As part of the Draft Plan of Subdivision, Official Plan Amendment and Zoning By-law Amendment for Phase 5 – Lakeside Village Community (herein referred to as the "2019 Applications"), an Environmental Impact Study (EIS) and supporting documents were submitted by the AON Inc., 2107401 Ontario Inc., Penryn Park Estates Inc., and Penryn Mason Homes Inc. ("Applicant").

The Municipality retained North-South Environmental Inc. (NSE) to undertake a peer review to provide a third party, science-based review of the Applicant's Environmental Impact Study (EIS). The purpose of the peer review is to ensure that an objective, professional analysis of the EIS and related information be completed to help inform the preparation of the requisite professional opinions by planning staff and other professionals as to whether or not the 2019 Applications meet the required tests for good planning including the Provincial Policy Statement 2020, relevant Provincial Guidelines, applicable Official Plan policies, etc.

March 16, 2021 Peer Review of Environmental Impact Study for a Residential Development in Port Hope, Ontario

Figure 1: 2020 Bifurcation-Deferral Proposal

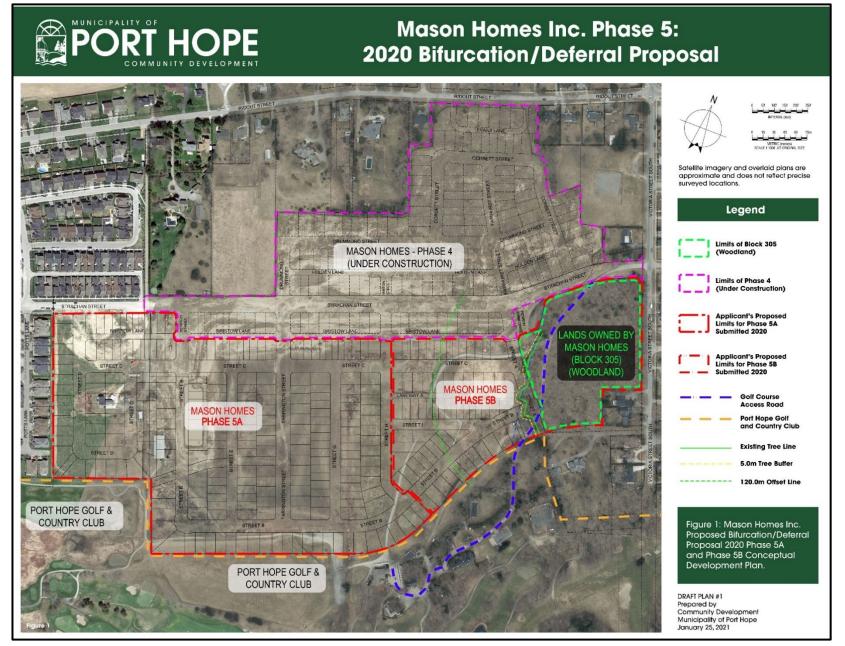
Staff's and NSE's understanding is that the Applicant's Bifurcation/Deferral Proposal divides the 2019 Application's Subject Lands into **Phase 5A** and **Phase 5B** (refer to Figure 1: 2020 Bifurcation-Deferral Proposal):

- **Phase 5A** <u>excludes</u> from development the woodlands and adjacent lands (i.e. a 120 m. minimum a buffer (zone) area immediately west of the woodland on the subject lands).
- Phase 5B <u>includes</u> the woodland and adjacent lands located on the eastern side of the subject lands.

Based on NSE and Staff's understanding of geographic location of the subject lands area - referred to as **Phase 5A** in the Applicant's Bifurcation/Deferral Proposal - should the Applicant choose to only proceed with a Phase 5A residential subdivision development at this time, then **an EIS or a revision** of the Applicant's 2019 Application **EIS would not be required**.

The woodland in the subject lands is shown in Schedule B1 of the OP as a Significant Woodland. Table 1 in the OP also identifies the extent of adjacent lands, which need to be considered in an EIS as being 120 metres. Since there is not a Natural Heritage Feature or adjacent lands as defined by the OP in what staff understands to be Phase 5A of the Bifurcation/Deferral Proposal, an EIS is not required if the Applicant limits the subdivision development application to Phase 5A.

However, if the Bifurcation/Deferral Proposal, as is understood by NSE and Staff, is not pursued and the Applicant proceeds with the development in all or any part of the woodland and/or within 120 m of the woodland on in the subject lands, it is NSE's (the peer reviewer's) recommendation that the EIS be revised and resubmitted, <u>prior to any approval of the original 2019 Applications</u>. An addendum to the original EIS would not be sufficient given the extent of comments and lack of adequate information.
